Technical Service Bulletin: tsb100721

Released Date: 30-Jul-2008

New LTA Water Pump

Figure 1, New oil feed.

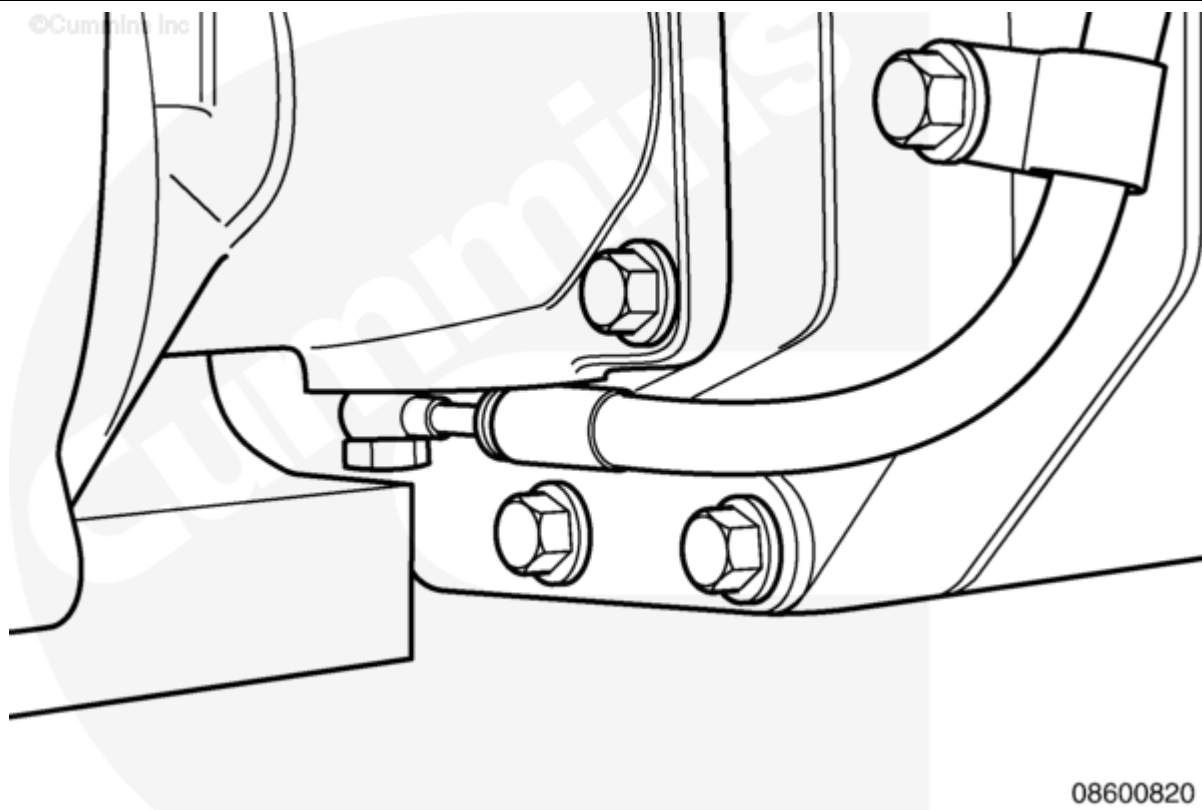
This Technical Service Bulletin introduces a revised LTA water pump, Part Number 3640492, and a new LTA water pump service kit, Part Number 4955807. The improvements include a change from a greased bearing to oil supplied bearings, which has increased lubrication. The oil feed is taken from the side of the gear cover.

Additional changes include improved water and oil seals, increased pump body strength, the introduction of a discharge cavitation plate, and drillings at the 6 o'clock and the 3 o'clock positions on the pump body for optional connection of the oil feed hose.

The older style and revised LTA water pumps look similar in appearance, due to the primary improvements occurring internally. Reference Figure 1.

Figure 2, Stiffening Rib (A).

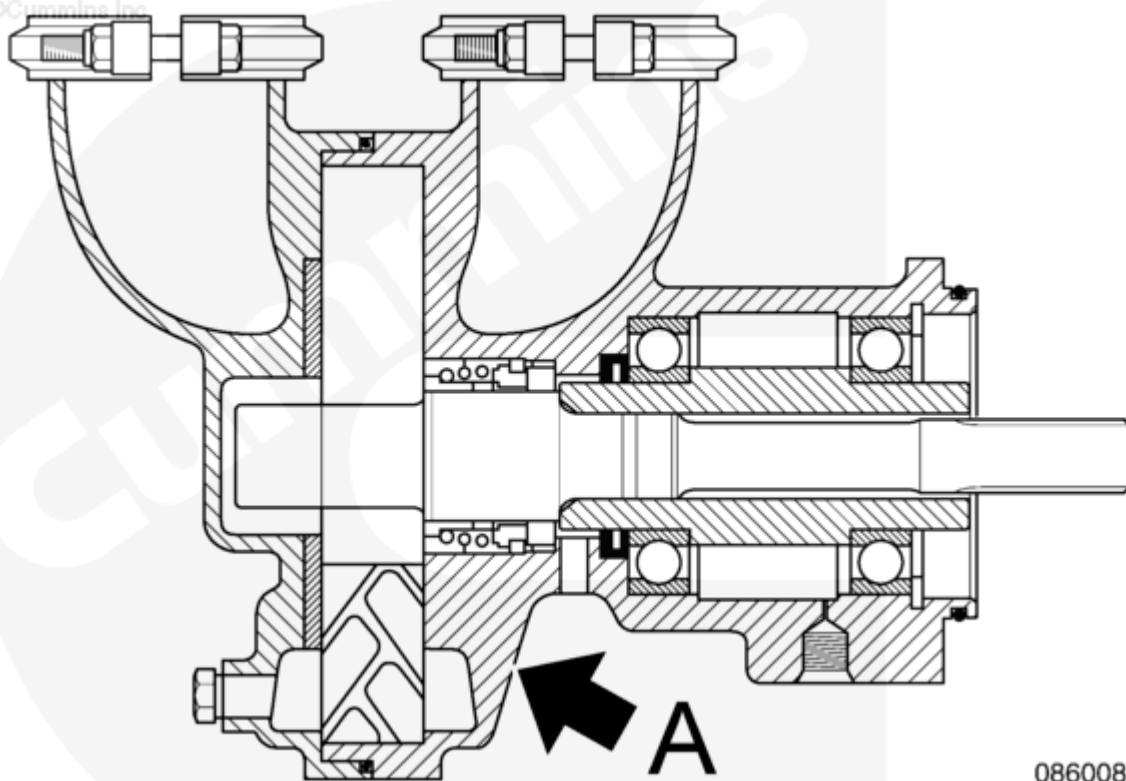
The strength of the water pump body has been improved by adding a stiffening rib, shown in the diagram below, and the introduction of a one-piece water pump body. Reference Figure 2.
